Subject: SSFL Area IV Radiological Characterization Survey -
Response to Comments

Responses to Comments of the Area IV Survey.

Comments by Dr. Lyou, Executive Director, Committee to Bridge the Gap
Letter, Lyou to Gaylord, 7 April 1997

Figure 1. Annual Exposure Rates vs. Distance from SSFL

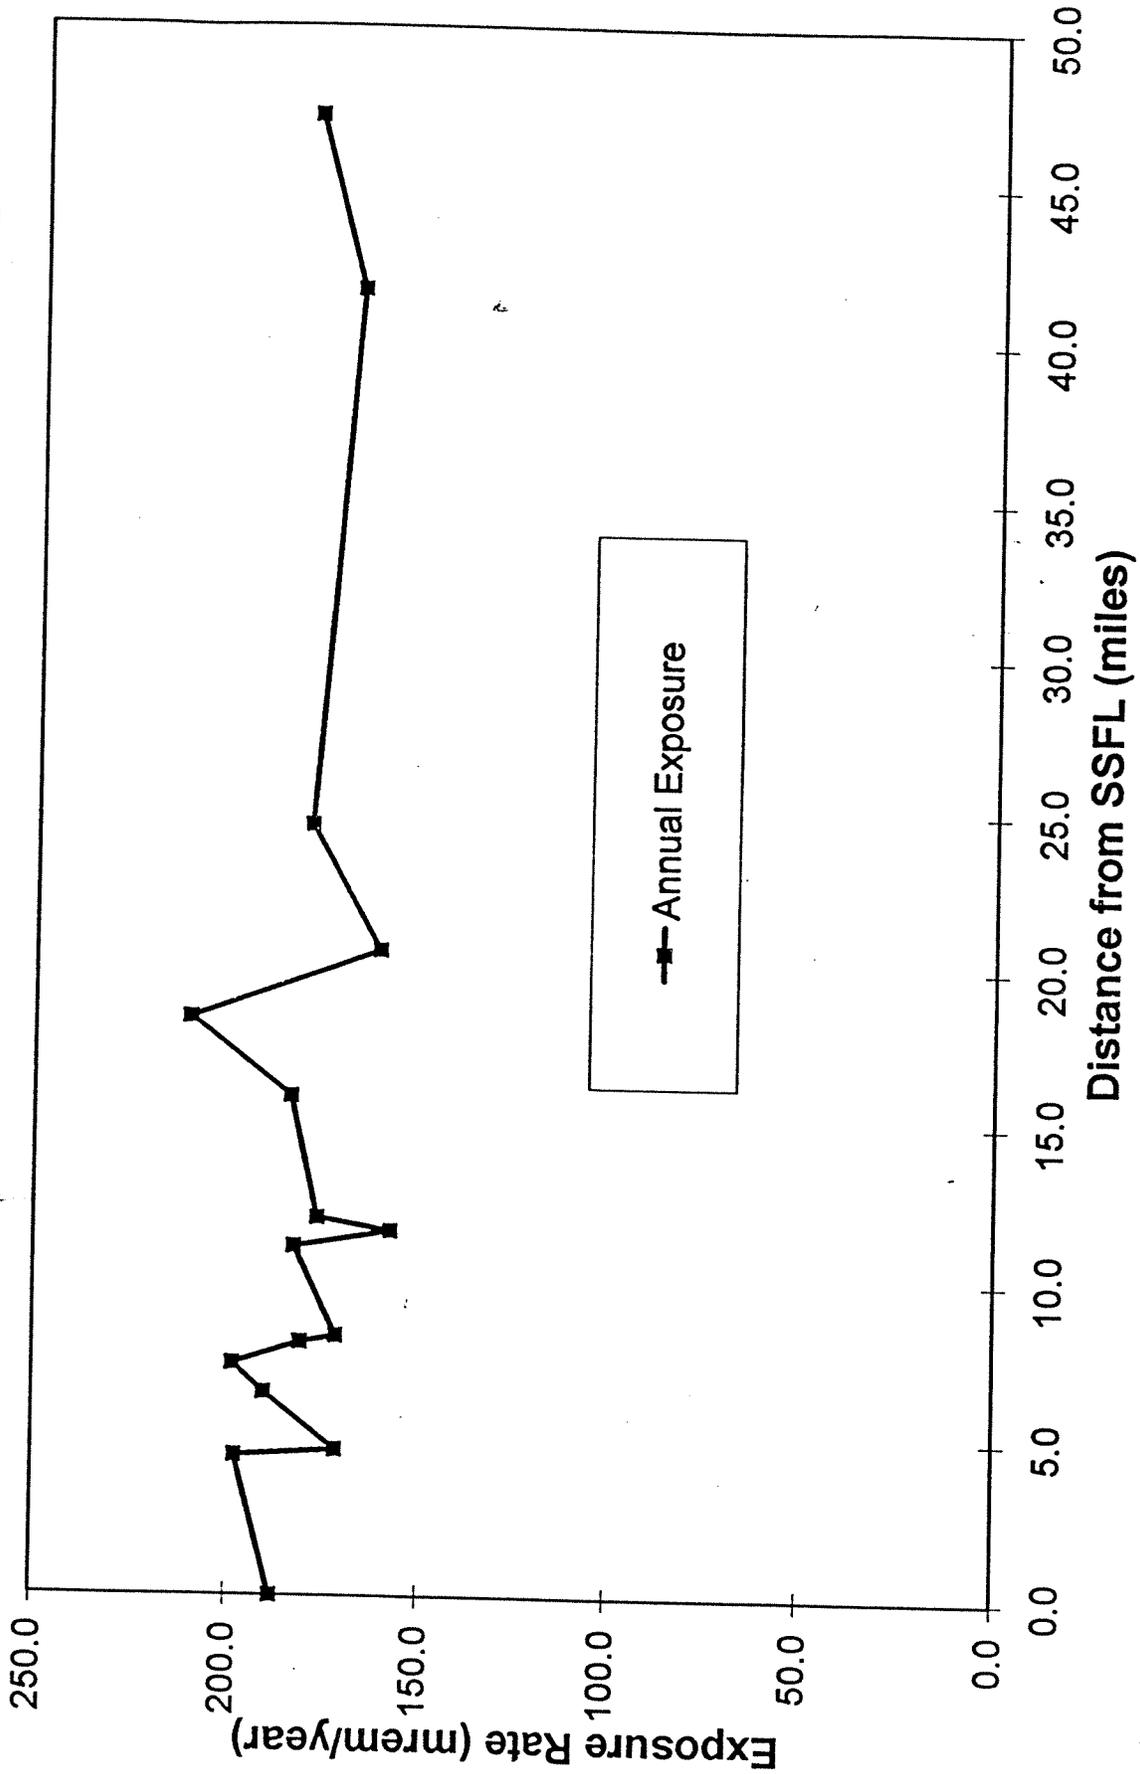
1. There could be many different choices of a background data set for comparison with SSFL Area IV radiation measurements. Since the purpose of the comparison was to determine if Rocketdyne operations had affected the radiation exposure rate in Area IV, compared to background, this is an important question. The best background set would be taken in an identical environment, with the same rocks, meadows, vegetation, situation, elevation, weather, and location. Since such an exact match is not possible in practice, we made considerable effort to make the background measurements match Area IV as well as possible, while excluding any areas that might even be suspected of showing any Area IV impact. Thus, nearby locations listed in the MultiMedia Study with names such as Radioactive Materials Disposal Watershed and Sodium Burn Pit Watershed, while sufficiently distant to avoid any radiation from on-site, were eliminated from the background comparison set. These measurements were not taken on-site, and furthermore, they were not included in the background set. Not only were the multimedia locations close to the boundary of SSFL not used as background locations for comparison in the Area IV report, but neither were any other of the measured locations on BBI or SMMC land used for background in this report.

Another set of data presented in section 5.3 of the 1995 Annual Site Environmental Report (RI/RD96-140) demonstrates that SSFL is not acting as a large radiation source whose effects can be felt at large distances. Each year radiation levels are measured using Aluminum Oxide TLDs placed on-site and at employees residences off-site. These TLDs accumulate total annual exposure (as opposed to a 1-minute measurement) and have higher sensitivity than NaI detectors. Figure 1 shows the average annual exposure at SSFL (selected sites at Area IV) and at off-site locations varying from 4.4 miles to 47 miles from SSFL and at differing directions from SSFL. The off-site locations include Simi Valley (2 sites), West Hills, Calabasas, DeSoto facility, Chatsworth, Northridge, Thousand Oaks, Moorpark, Somis, Saugus, North Hollywood, Burbank, Quartz Hill and

Lancaster. It is apparent that there is no trend of decreasing radiation exposure with distance from SSFL. The average annual exposure is 181 mrem/year with an observed range of +/- 30 mrem/year.

Figure 2. Comparison of radioactivity in soils and exposure rate

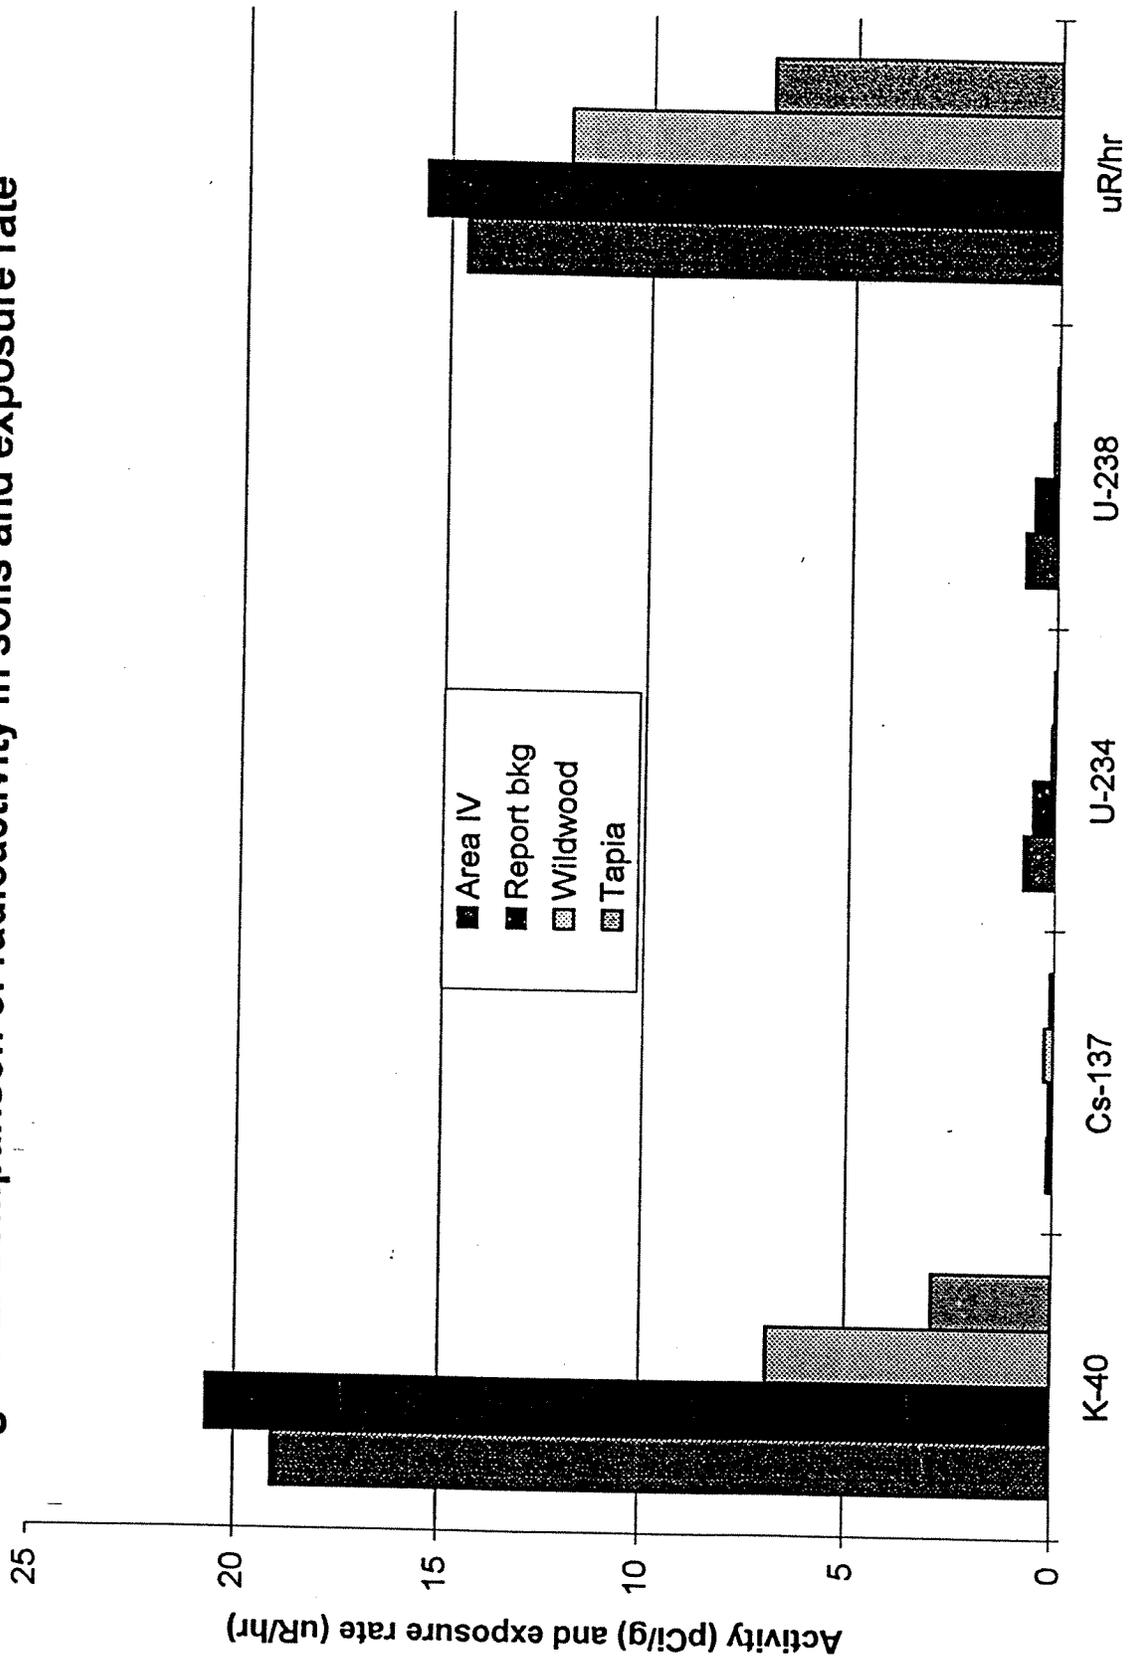
4. While all background measurements were made off-site, those measurements that had been made near the boundary, or anywhere on the BBI and SMMC property, were omitted. Measurements made in Tapia Park and Tapia Park Ravine were exceptionally

low and the soil analyses showed that this was so because the radioactive elements potassium, thorium, and uranium that are naturally present in the soil of our locale were barely present in the Tapia soil. Therefore, the Tapia data, and for the same reason, Wildwood Park and Wildwood Park Ravine data, were dropped from the background data set. They were eliminated because the concentration of natural radioactivity in the soil was grossly different and not at all typical of the Simi Hills soil, not because they produced low exposure rate readings. They did produce low readings because they were deficient in natural radioactivity. This was revealed in the graphical tests used to inspect the data before use. These differences are shown in the bargraph in Figure 2, where the Wildwood and Tapia soil analyses show lower amounts of K-40, one of the major natural sources of gamma radiation, and lower gamma exposure rates. Clearly, different soils make different backgrounds. The statistical comparison requires that similar environments be used.
